Subject: Issuance of Amendment No. 35 to Facility Operating  
License No. NPF-21 - WPPSS Nuclear Project No. 2

AMENDMENT NO. 35 TO FACILITY OPERATING LICENSE NO. NPF-21  
WPPSS NUCLEAR PROJECT NO. 2

SUPPORTING AMENDMENT NO. 35 TO FACILITY OPERATING LICENSE NO. NPF-21

FIGURE 3.4.6.1-1

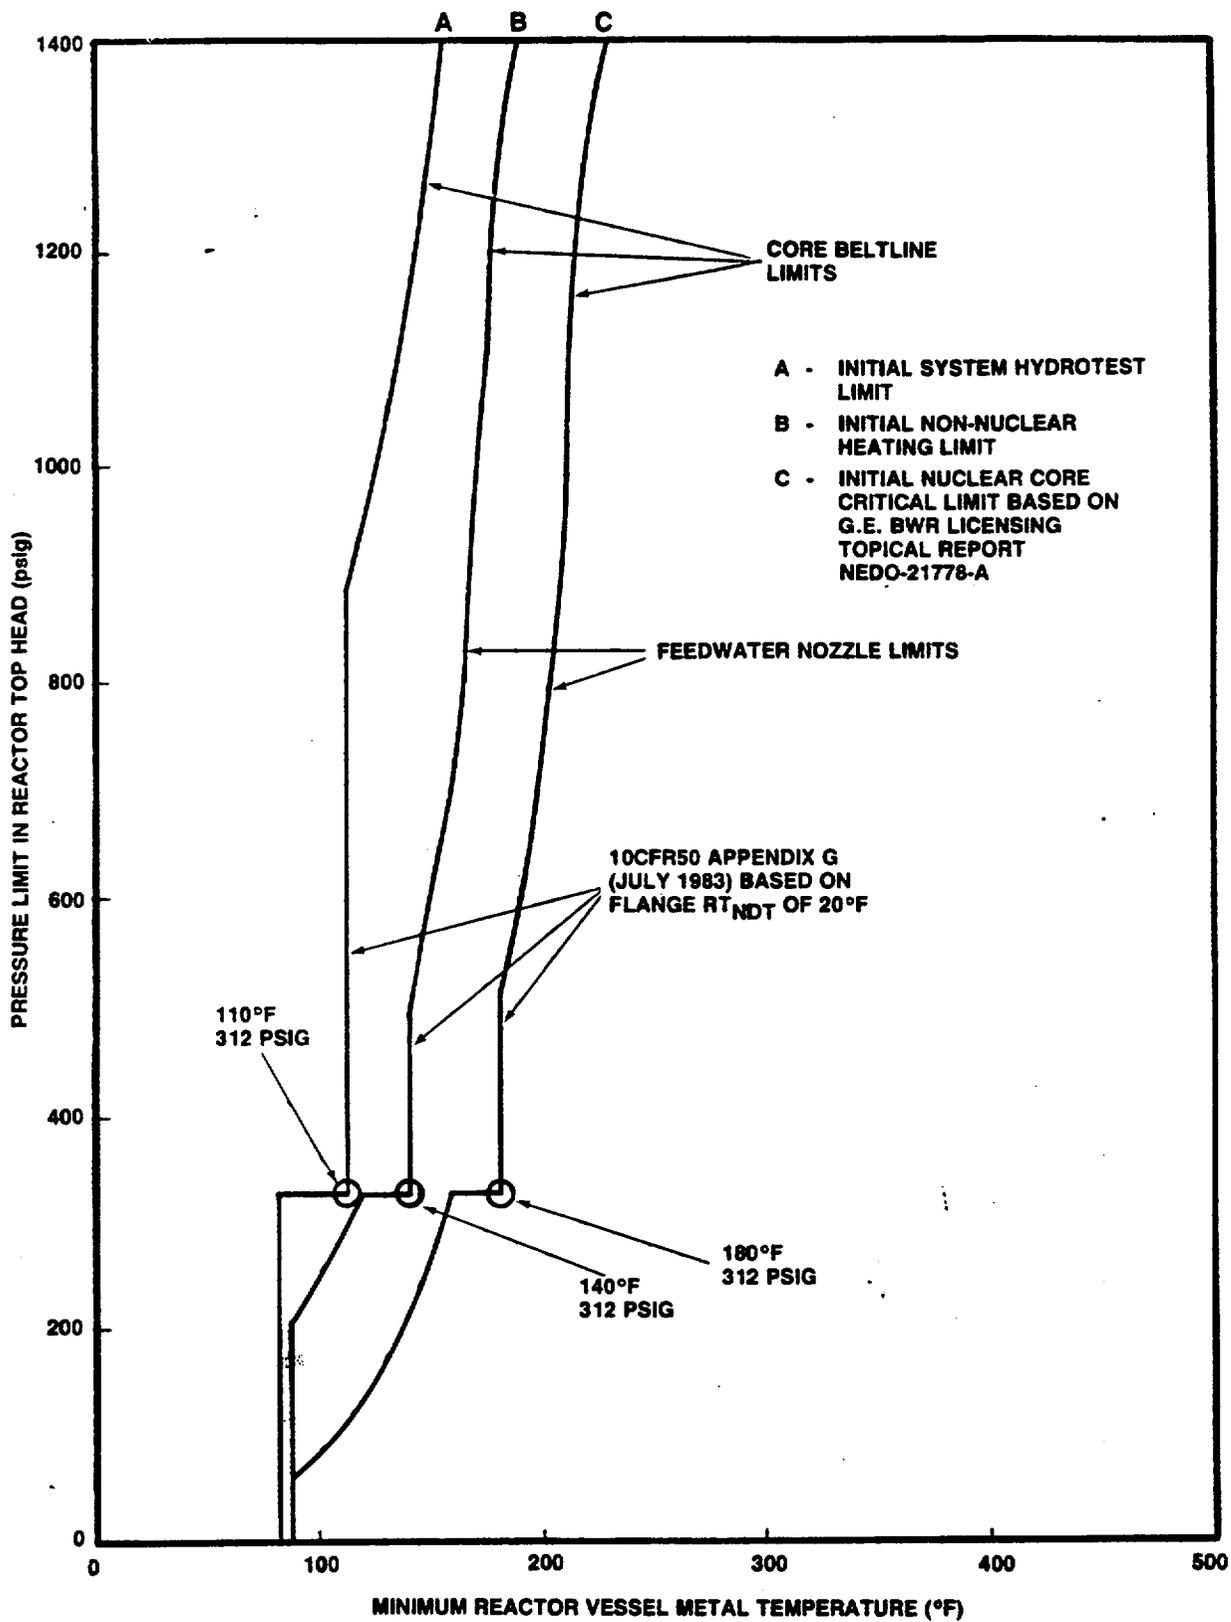
This amendment revises Sections 3.4.6.1 (Pressure/Temperature Limits) of the WNP-2 Technical Specifications by shifting the relationships in the pressure/temperature curves, Figures 3.4.6.1-1 and 3.4.6.1-2, 30°F higher at 20% of the preservice hydrostatic test pressure. This change is in compliance with the requirements of paragraph IV.A.2 of 10 CFR Part 50, Appendix G.

In a letter to the Commission dated January 31, 1986, the Washington Public Power Supply System requested an amendment to Section 3.4.6.1 of the WNP-2 Technical Specifications. The request was made to revise Figures 3.4.6.1-1 and 3.4.6.1-2 in order to comply with the requirements of paragraph IV.A.2 of Appendix G of 10 CFR Part 50.

The revised pressure/temperature curves have been shifted 30°F higher at 20% of the preservice hydrostatic test pressure for compliance with the requirements of paragraph IV.A.2 of Appendix G. Because the revised curves are more conservative, they will provide an additional margin of safety for reactor vessel testing and operation; and because the changes are required by the regulations, they are acceptable.
